BUILDING INSPECTION PERMIT

AT 93 HOBART ST L 197 H001004

Past Use: Single Family Home	Proposed Use: 2 unit- Add second dwelling unit. - 32' x 18'	Permit Fee: \$996.00	Cost of Work: \$100,000.00	CEO District: 3
---------------------------------	--	-------------------------	-------------------------------	--------------------

In regards to: 93 Hobart Street Addition (Chuck Barnard)

THIS IS A PARTIAL VIEW OF PAGE 3 OF THE DRAWING SET FOR 93 HOBART STREET. THE CLOUDED CHANGES ARE ADDENDA TO THE ORIGINAL SET DATED 4-10-06. THESE CHANGES ARE TO BE CONSIDERED PART OF THE FINAL PERMIT AND CONSTRUCTION DOCUMENTS

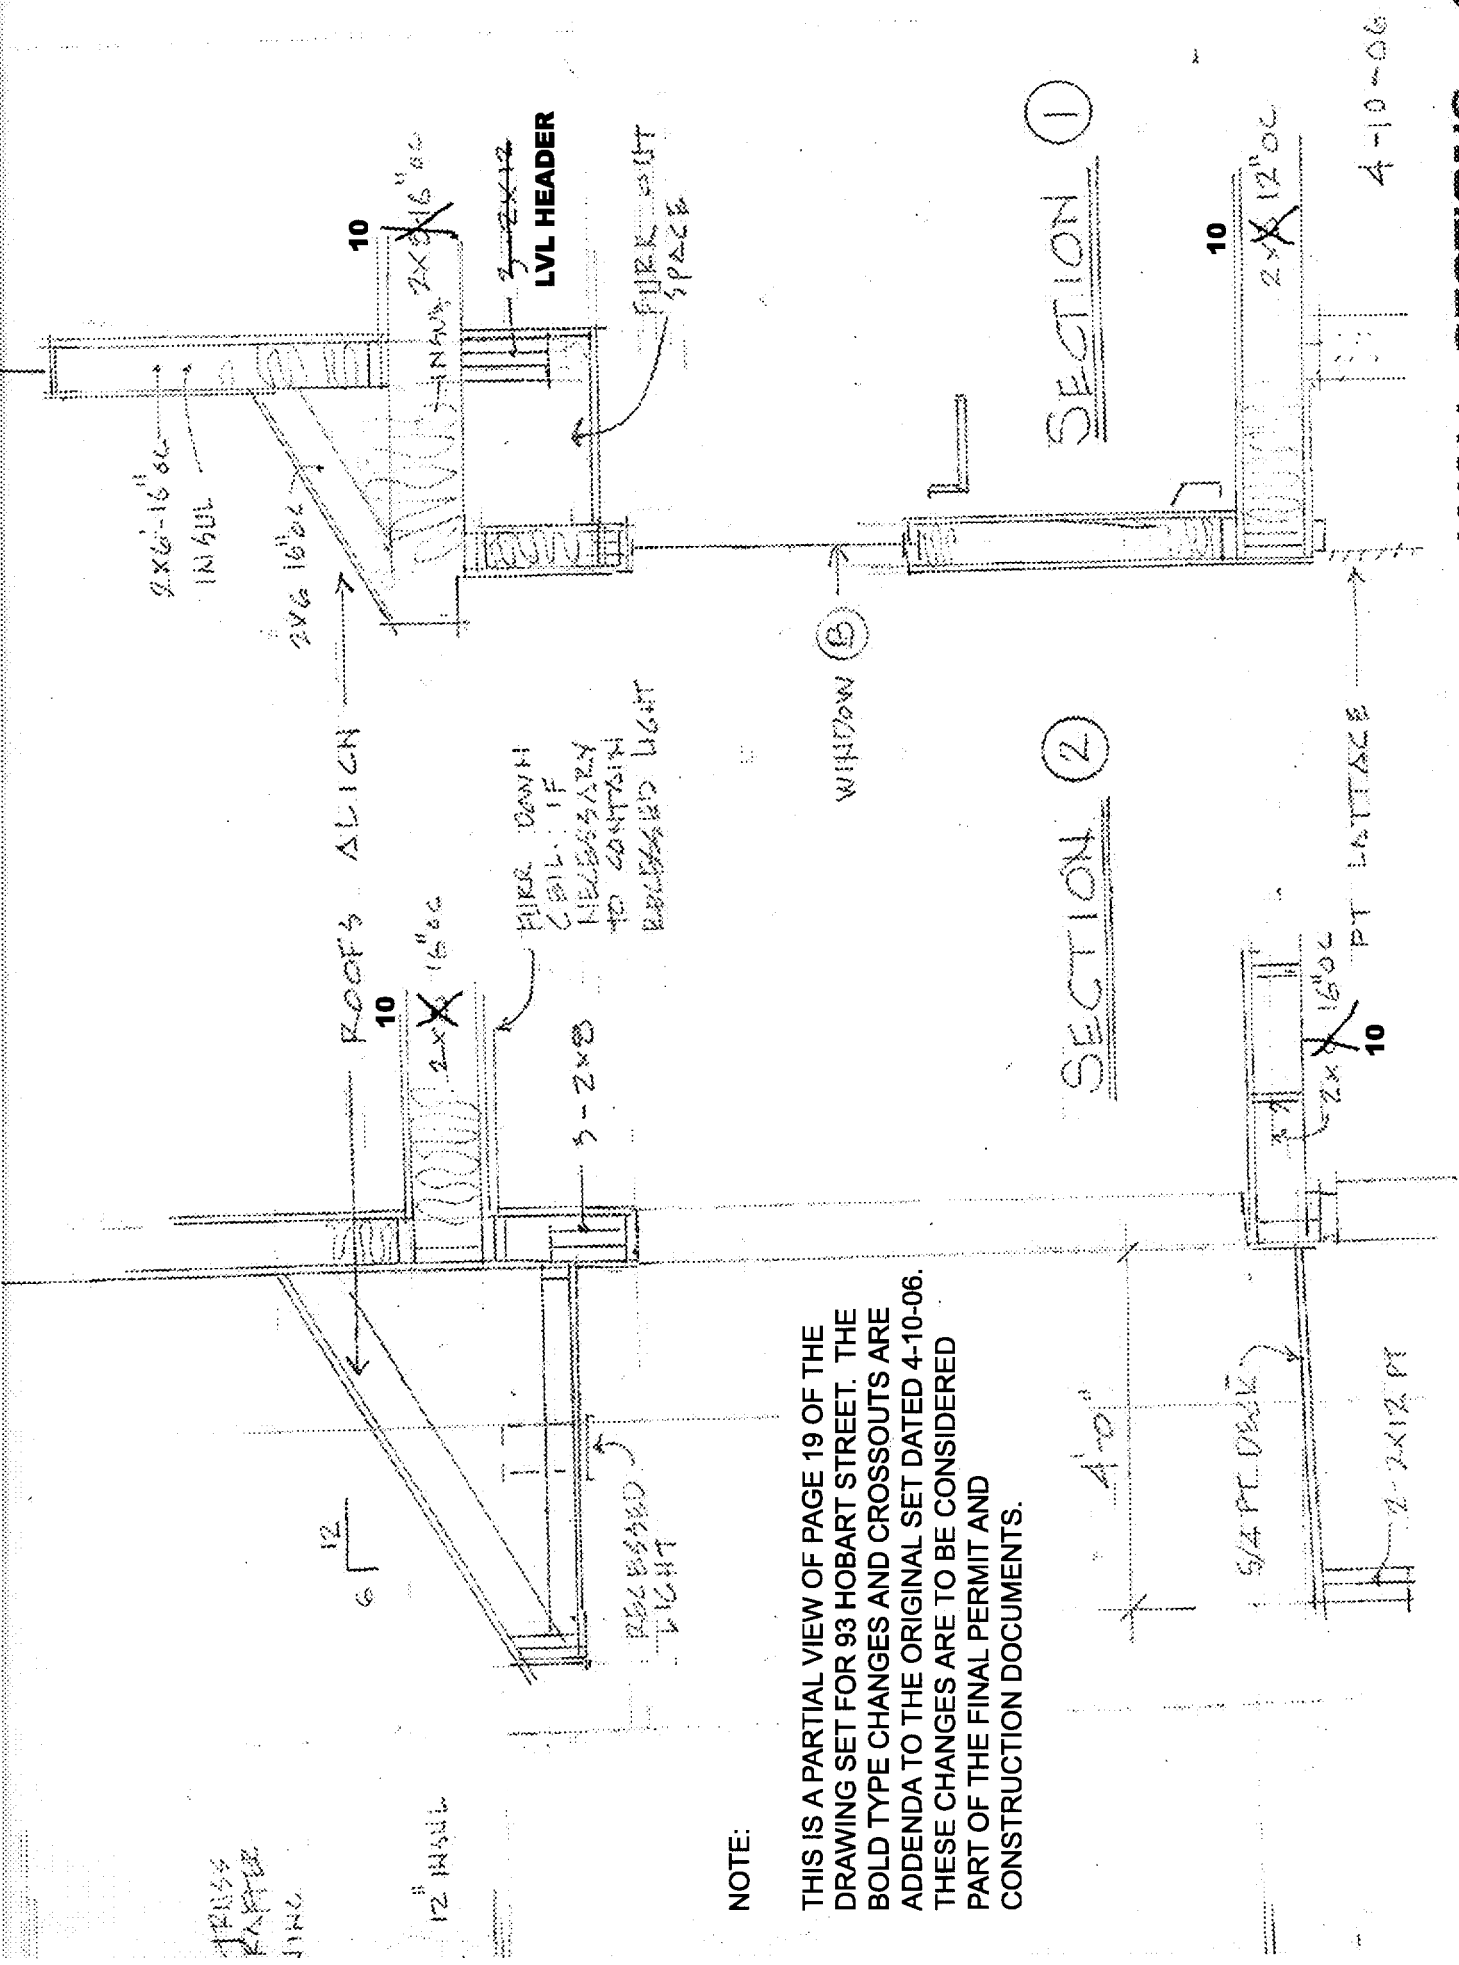
APARTMENT PARTY WALL TO BE CONSTRUCTED AS FOLLOWS:

- REMOVE EXISTING SIDING, SHEATHING AND INSULATION-EXISTING INTERIOR DRYWALL TO REMAIN- MODIFY AS REQUIRED TO MEET UL 263 U305 REQUIREMENTS.
- PARTY WALL CONSTRUCTION SHALL BE IN ACCORDANCE WITH UL 263 U305 TO ACHIEVE 1 HOUR FIRE RESISTIVE CONSTRUCTION AND AN STC RATING OF 56

NOTE:
THIS IS A PARTIAL VIEW OF PAGE 12 OF THE DRAWING SET FOR 93 HOBART STREET. THE CLOUDED CHANGES ARE ADDENDA TO THE ORIGINAL SET DATED 4-10-06. THESE CHANGES ARE TO BE CONSIDERED PART OF THE FINAL PERMIT AND CONSTRUCTION DOCUMENTS.

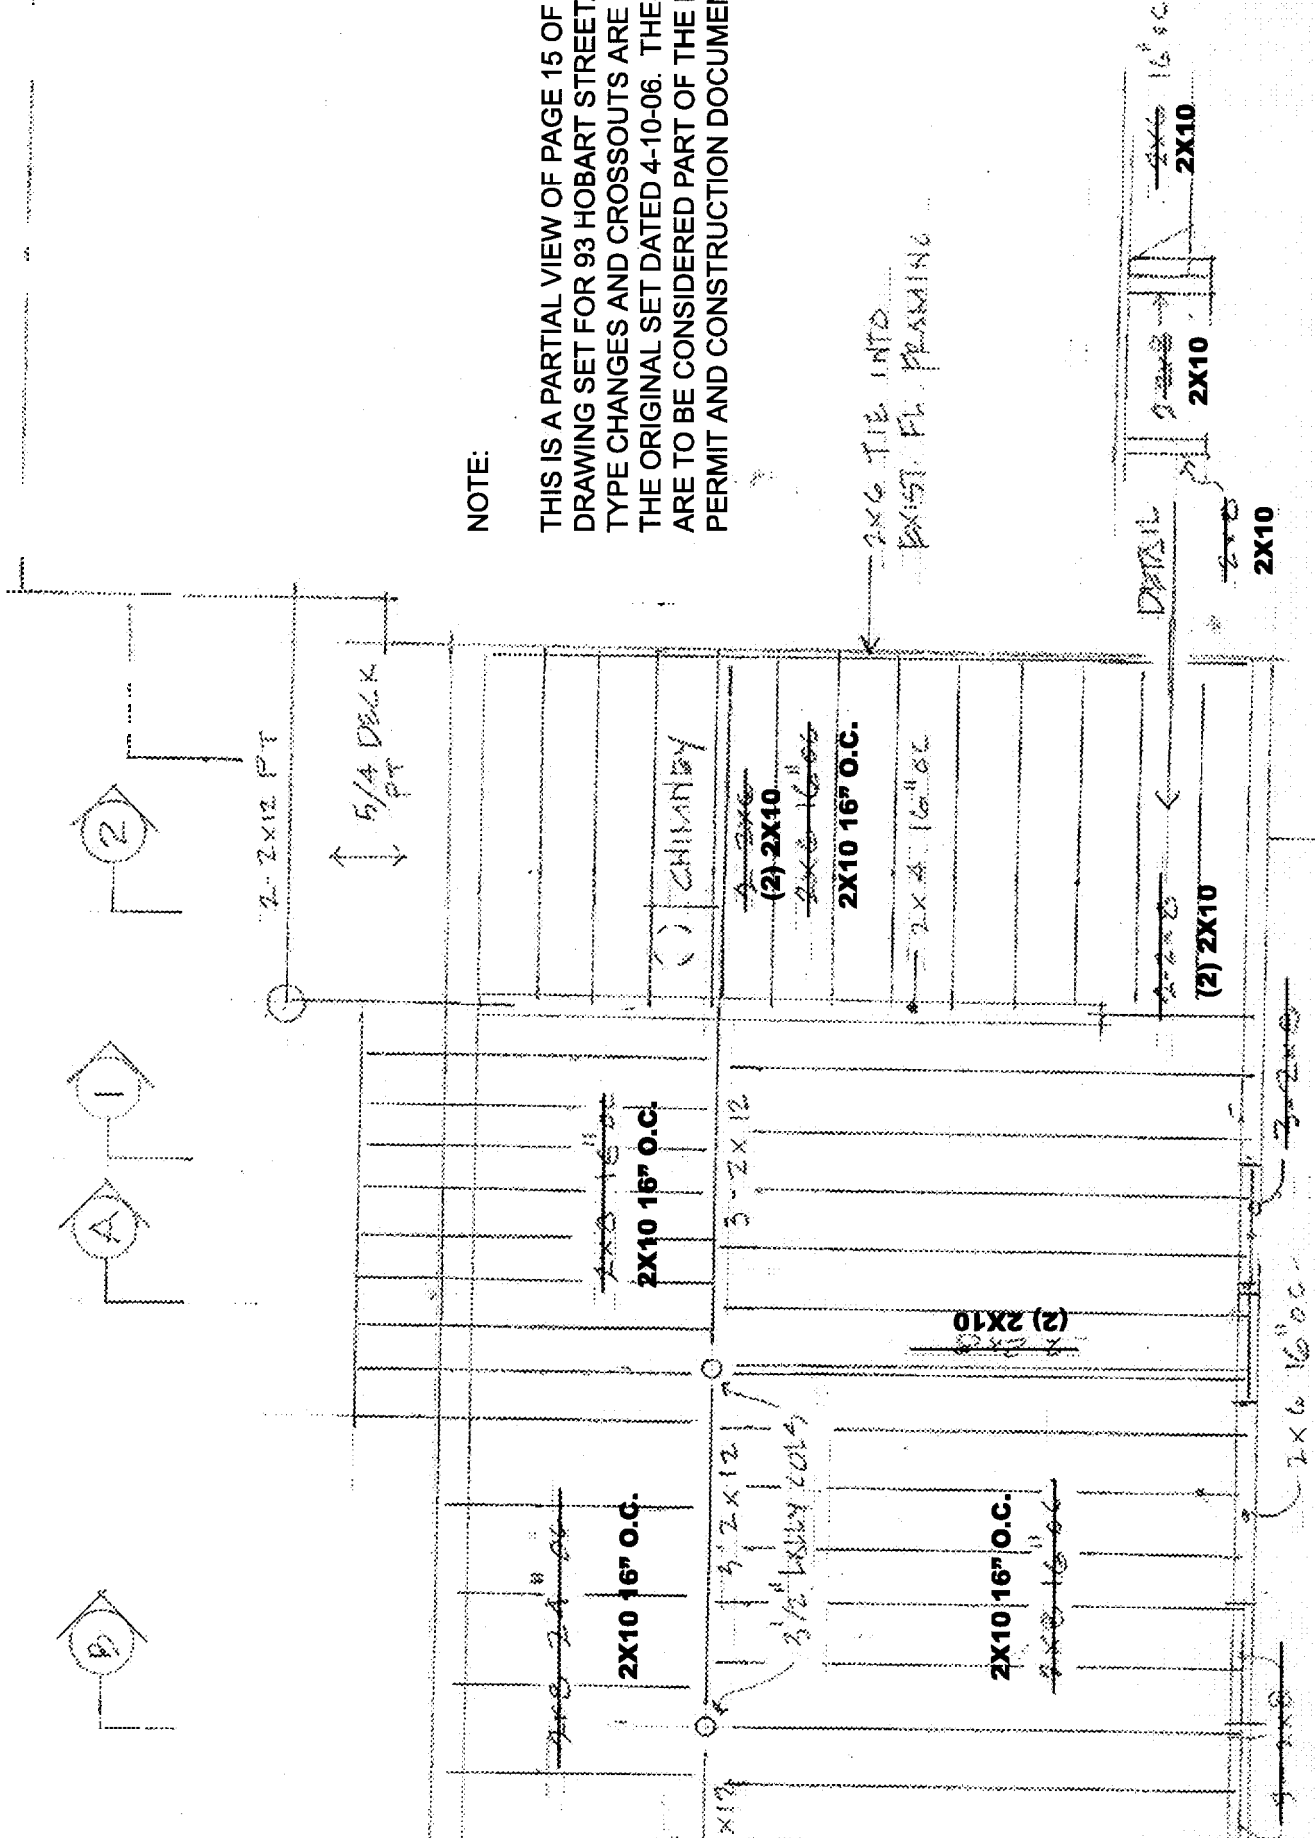
D 3'-0" X 6'-0"

VINYL CLAD SLIDING (GLIDER)
ANDERSEN G63 OR EQUIVALENT

NOTE: THIS WINDOW MUST MEET OR EXCEED ALL APPLICABLE EGRESS REQUIREMENTS

ADD TO THE WINDOW SCHEDULE WINDOW "D" AS SHOWN
